# READILY ACHIEVEABLE PLANS FOR CITY FACILITIES TO MEET TEXAS ACCESSIBILITY STANDARDS

**CITY OF SMITHVILLE  
READILY ACHIEVABLE PLANS FOR CITY FACILITIES  
NEW TEXAS ACCESSIBILITY STANDARDS (TAS)  
SITE PLAN EXHIBITS AND BUDGET COST ESTIMATES  
NOVEMBER 2013  
BEFCO JOB NO. 12-5733**

**CITY OF SMITHVILLE  
READILY ACHIEVABLE PLAN #1  
RECREATION CENTER  
(SITE AND BUILDING ASSESSMENT)  
November 2013  
BEFCO JOB NO. 12-5733**

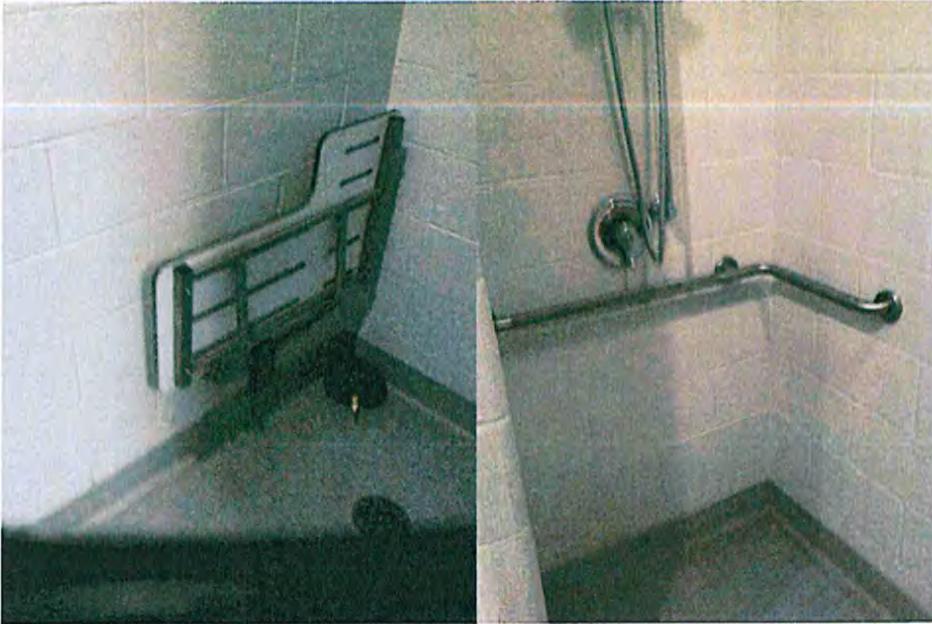
**Unacceptable: 904.4.1 Parallel Approach.** A portion of the counter surface that is 36 inches (915 mm) long minimum and 36 inches (915 mm) high maximum above the finish floor shall be provided. A clear floor or ground space complying with 305 shall be positioned for a parallel approach adjacent to the 36 inch (915 mm) minimum length of counter.

**Notes: The front desk information counter exceeds 36".**

1. Reconstruction of a portion of counter to provide an accessible height - **\$3,000**
2. Place flush valve on correct side of women's accessible toilet - **\$3,000**
3. Attach men's seat and move women's seat to correct wall in shower facilities - **\$1,500**
4. Replace door knob into handball court with lever action handle - **\$500**

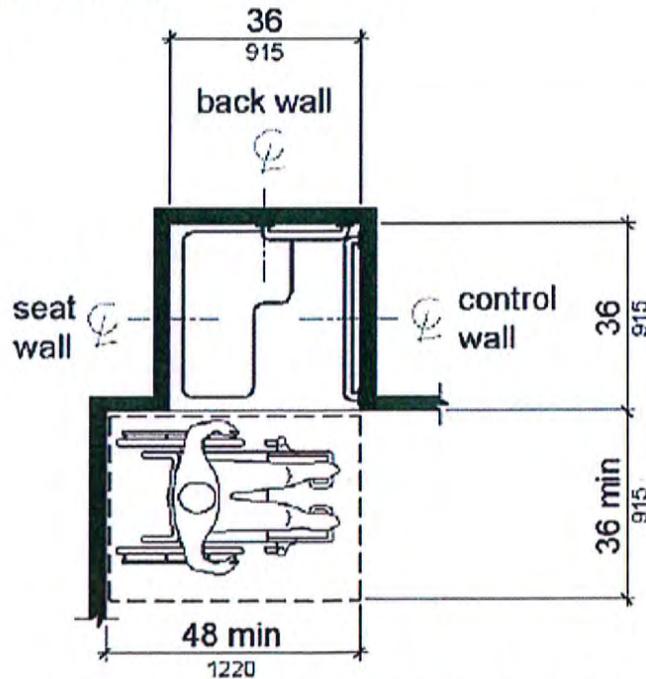
**Unacceptable: 608.2.1 Transfer Type Shower Compartments.** Transfer type shower compartments shall be 36 inches (915 mm) by 36 inches (915 mm) clear inside dimensions measured at the center points of opposing sides and shall have a 36 inch (915 mm) wide minimum entry on the face of the shower compartment. Clearance of 36 inches (915 mm) wide minimum by 48 inches (1220 mm) long minimum measured from the control wall shall be provided.

**Notes:** The men's seat is not attached and the women's seat is on the wrong wall, see the attached drawing.

**CITY OF SMITHVILLE ~ SKATE PARK**  
**Readily Achievable Plan #2**

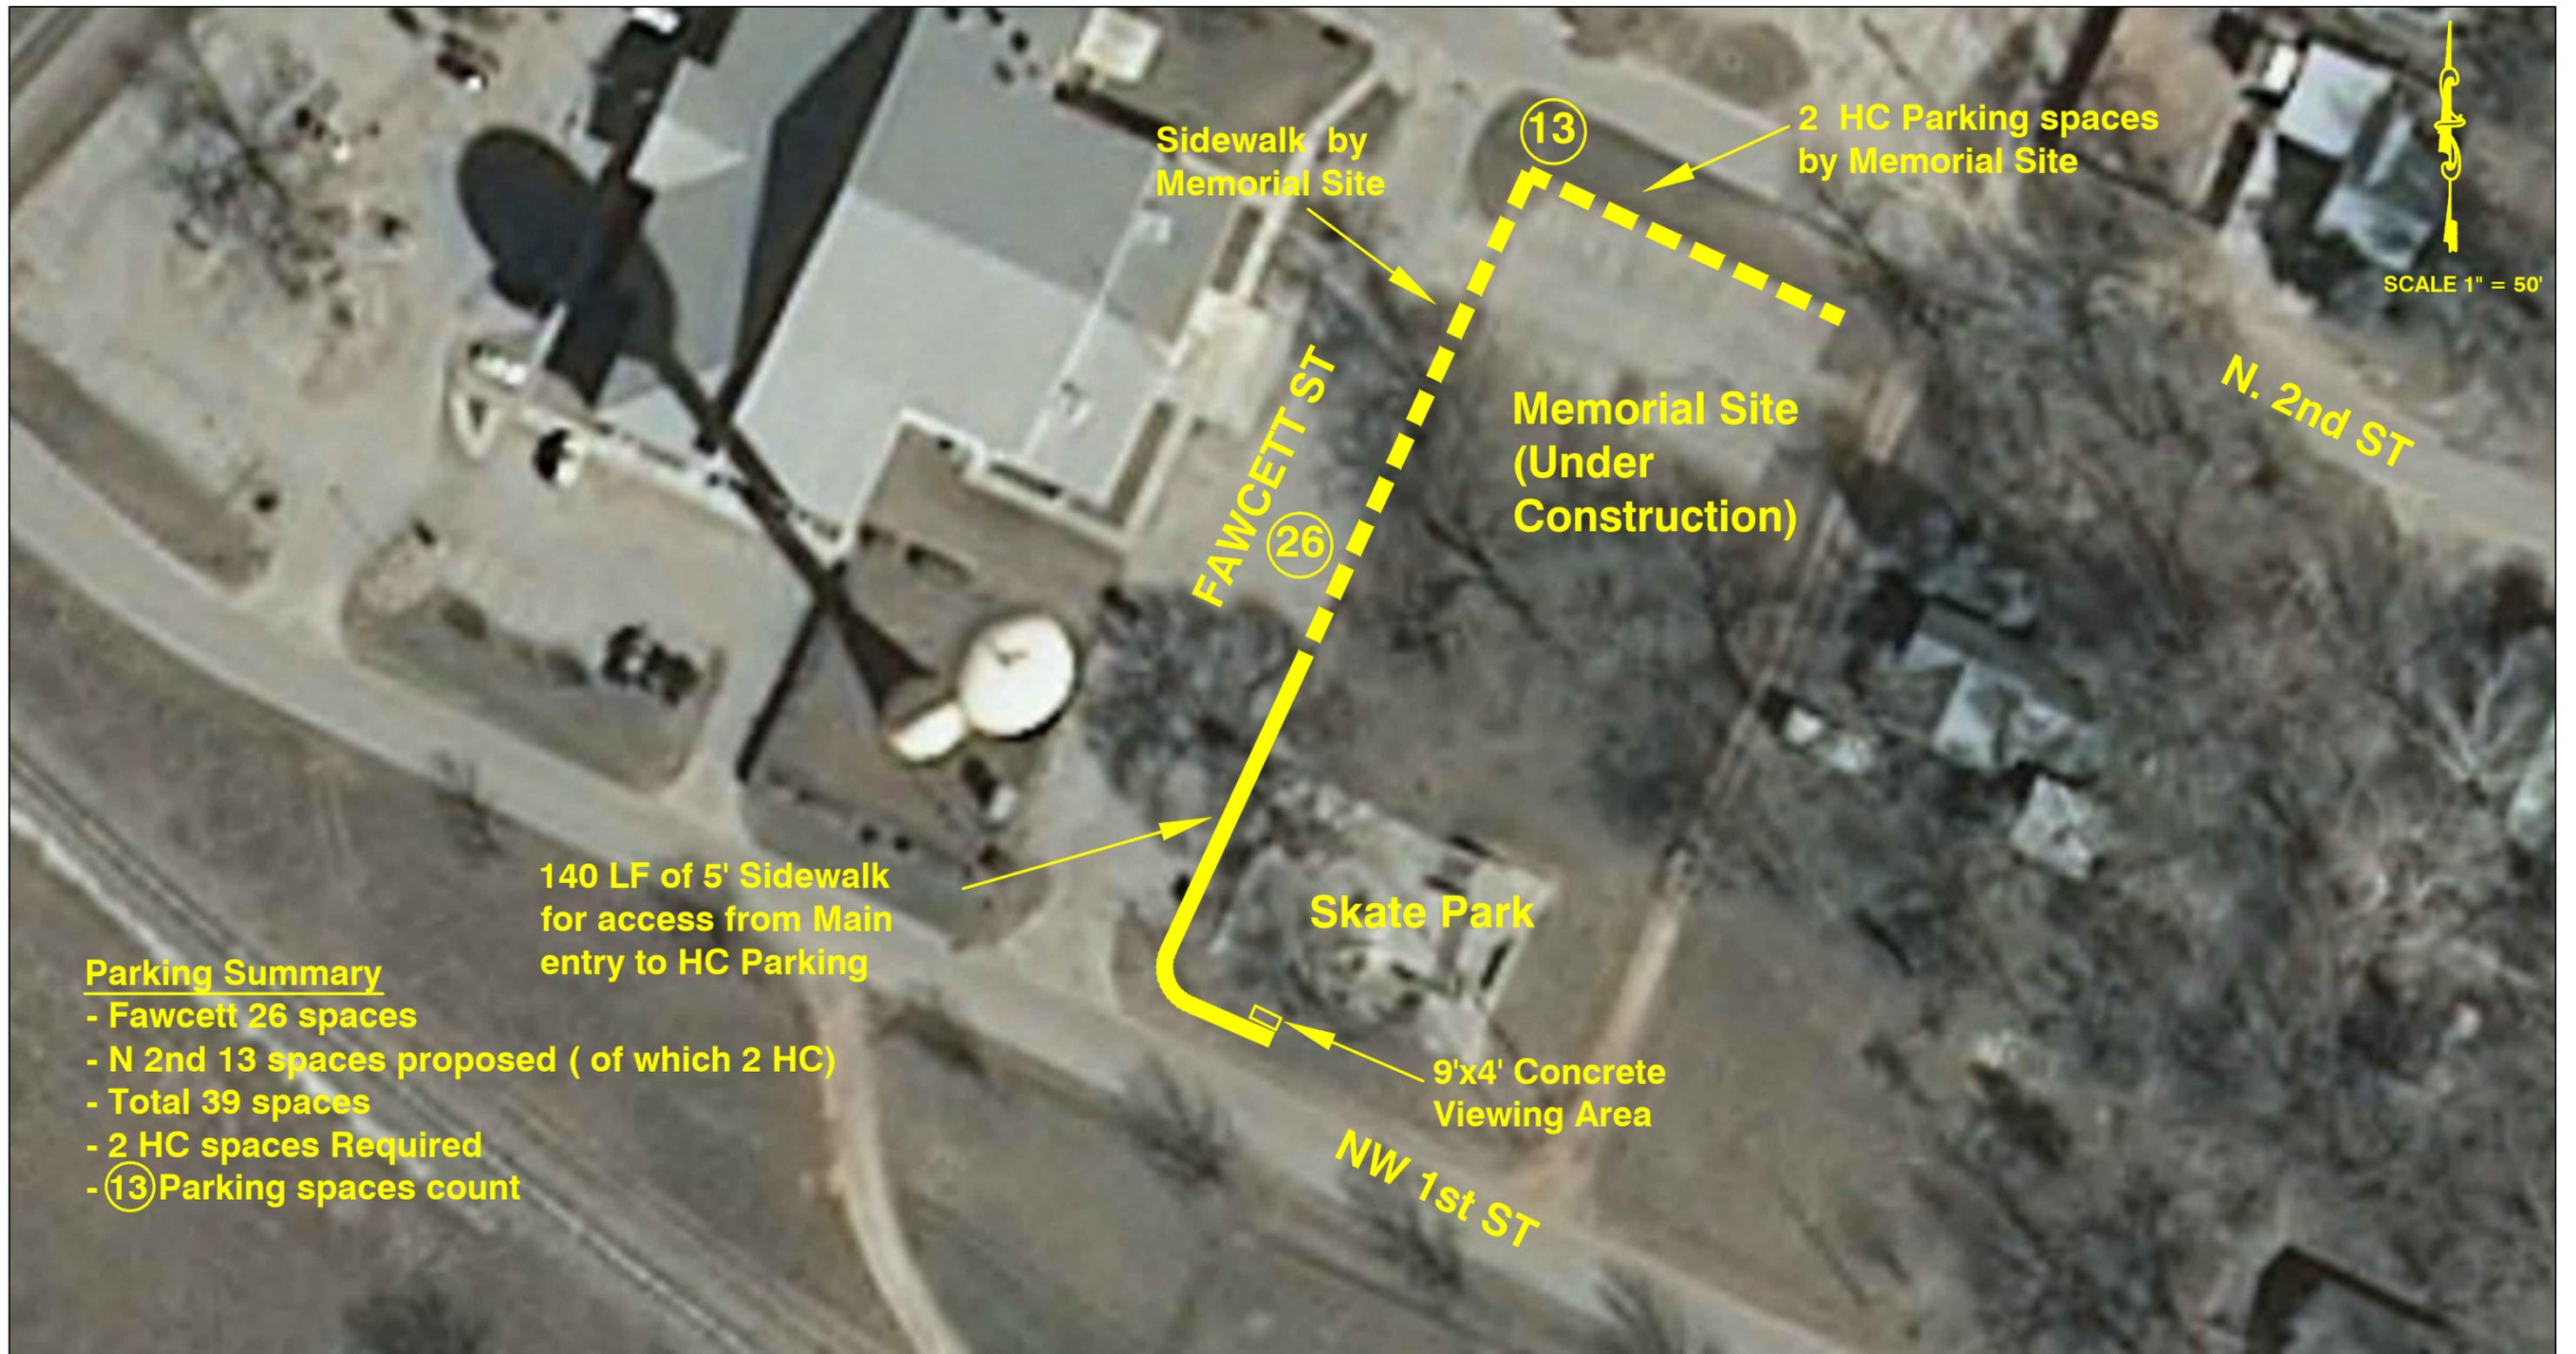
1. Install 140 feet of 5' sidewalk for access from skate park entry to handicap parking spaces on 2<sup>nd</sup> street and access to viewing area (700 sf @ \$8/sf) - **\$5,600**
2. Install 9'x4' concrete pad for viewing area of skate park (36 sf @ \$8/sf) - **\$300**

140 LF of 5' Sidewalk for access from Main entry to HC Parking

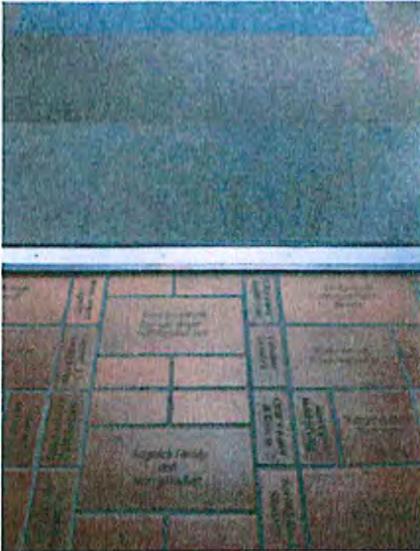
**Unacceptable: 502.4 Floor or Ground Surfaces.** Parking spaces and access aisles serving them shall comply with 302. Access aisles shall be at the same level as the parking spaces they serve. Changes in level are not permitted. **EXCEPTION:** Slopes not steeper than 1:48 shall be permitted.

**Notes:** The existing accessible parking space and the access aisle exceeds 2% in either direction

1. Reconstruct HC parking area\add signage (360 sf @ \$15/sf) including demo\disposal for one new handicap parking space including 100 sf of sidewalk improvements and 2 new handicap ramps - **\$10,000**
2. Remove existing signage referencing accessible entrance at rear of building - **\$50**

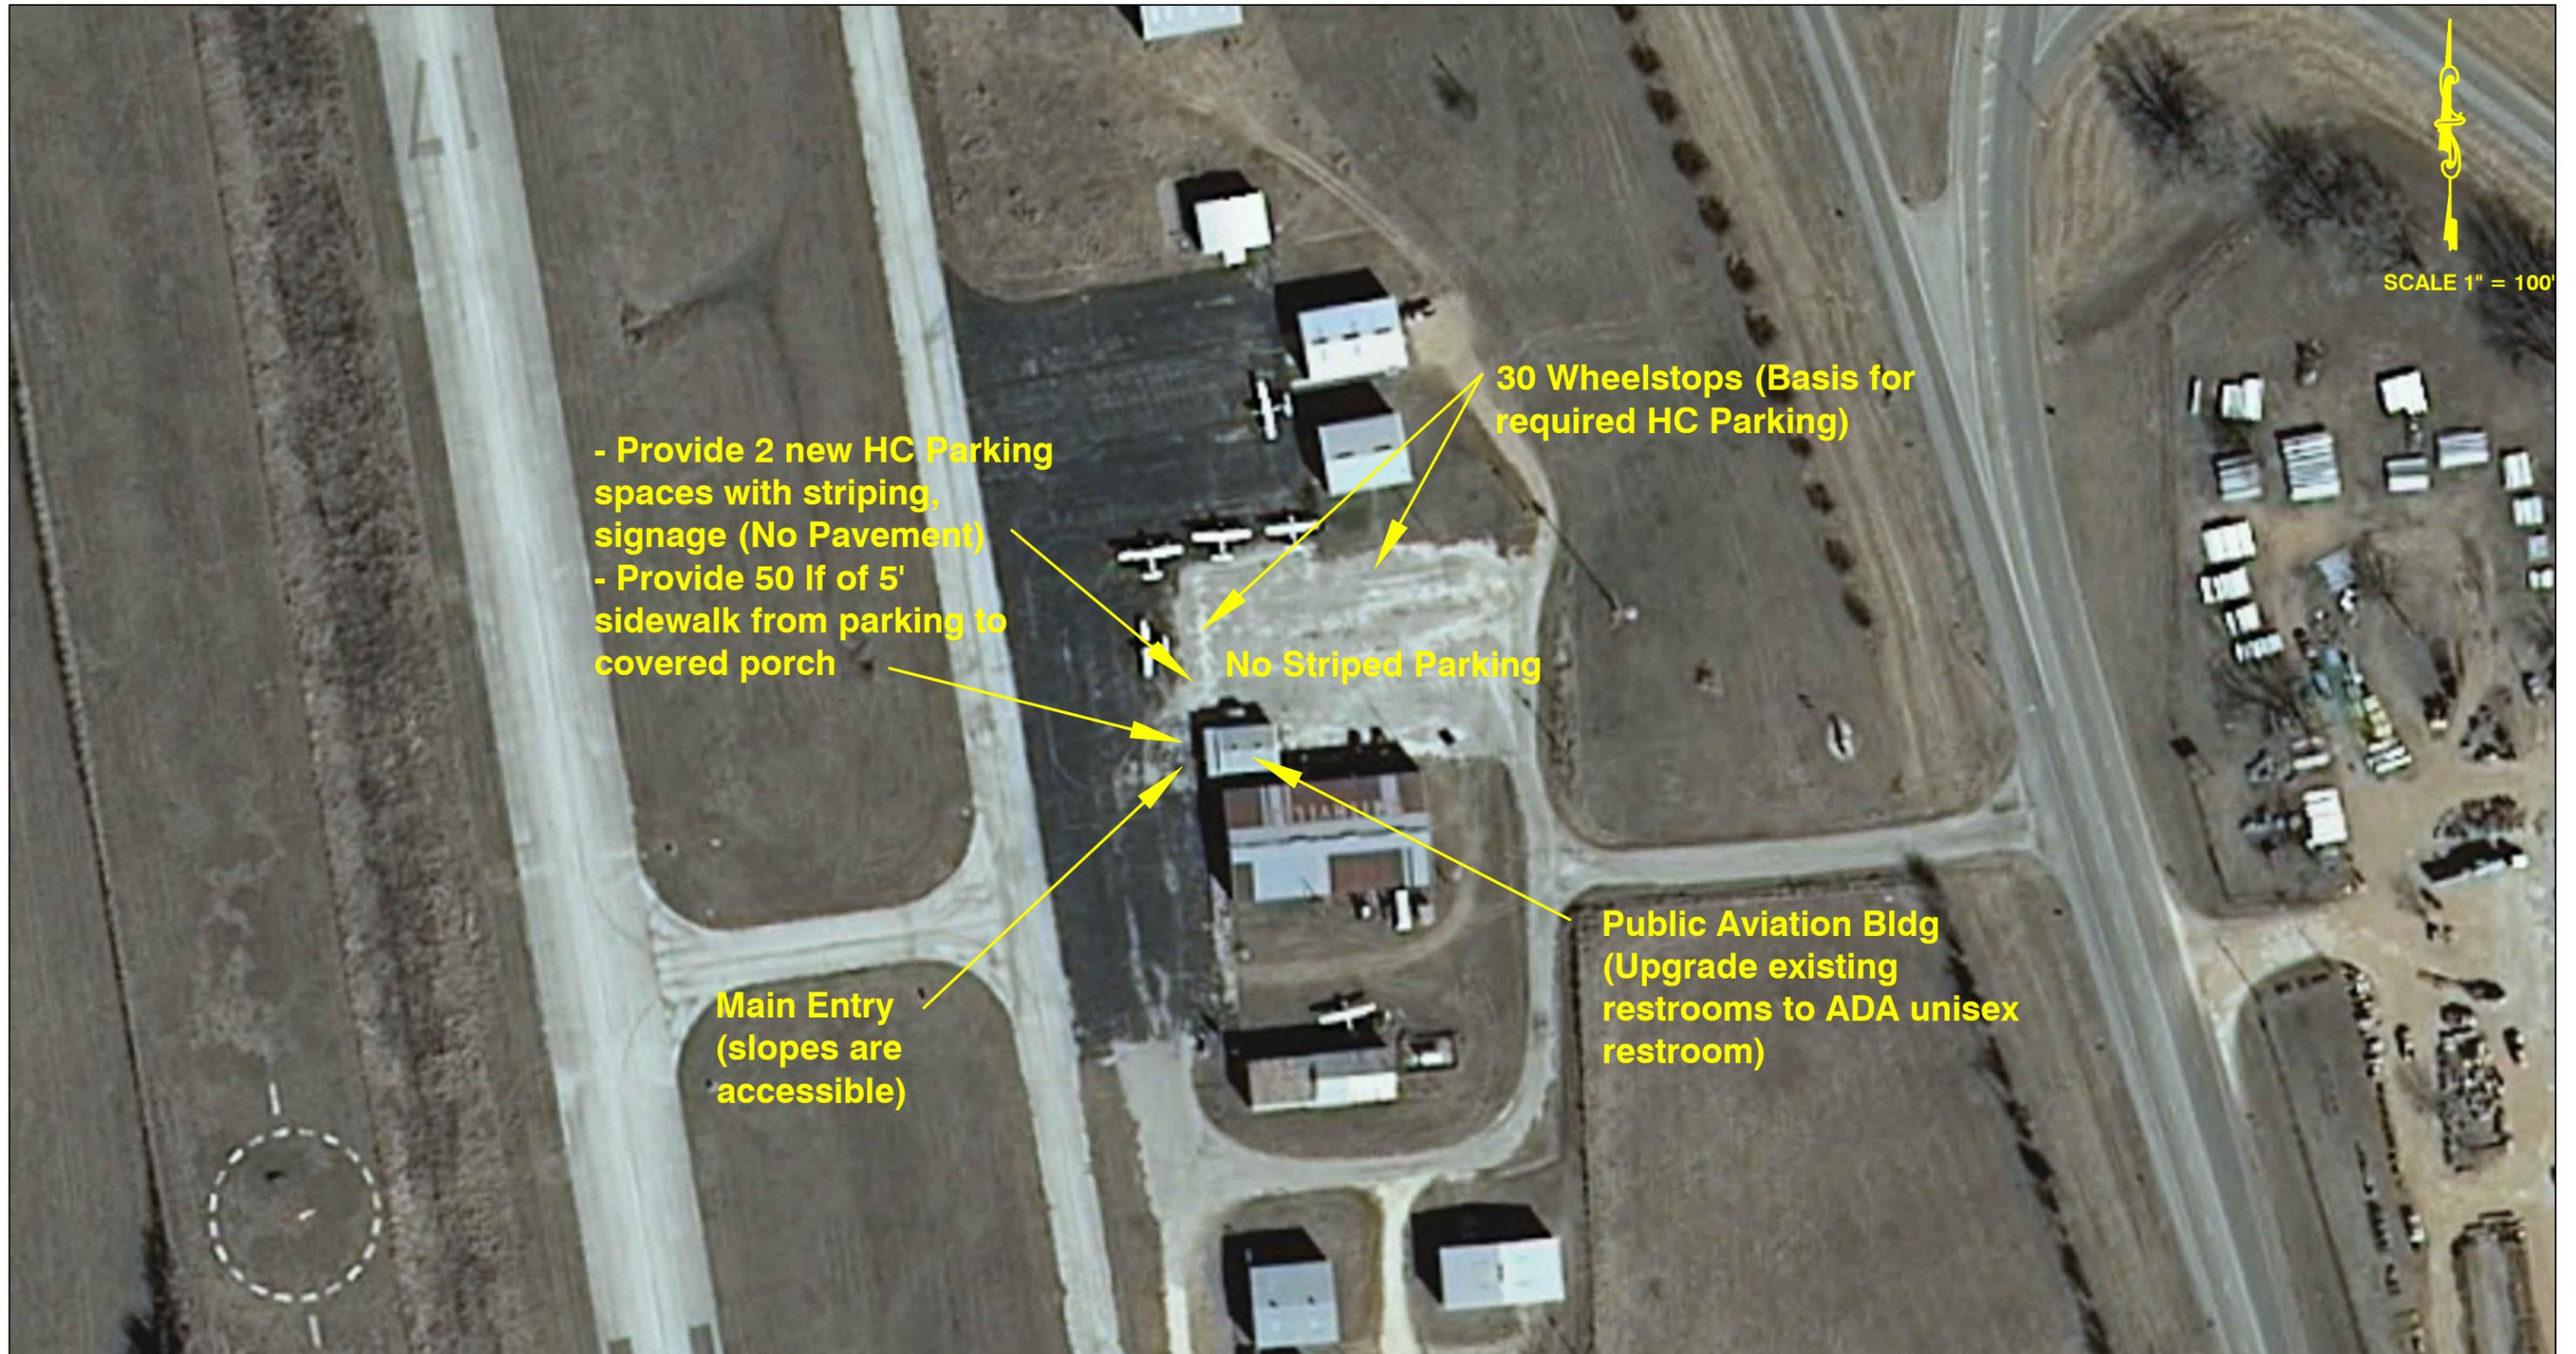
**Unacceptable: 309.4 Operation.** Operable parts shall be operable with one hand and shall not require tight grasping, pinching, or twisting of the wrist. The force required to activate operable parts shall be 5 pounds (22.2 N) maximum.

**Notes: The hardware to enter the restroom is a knob style, this must be a lever action type.**

1. Reconstruct restroom for a unisex restroom to provide handicap accessible facilities including lever action door hardware – allowance provided and subject to detailed design **-\$20,000**
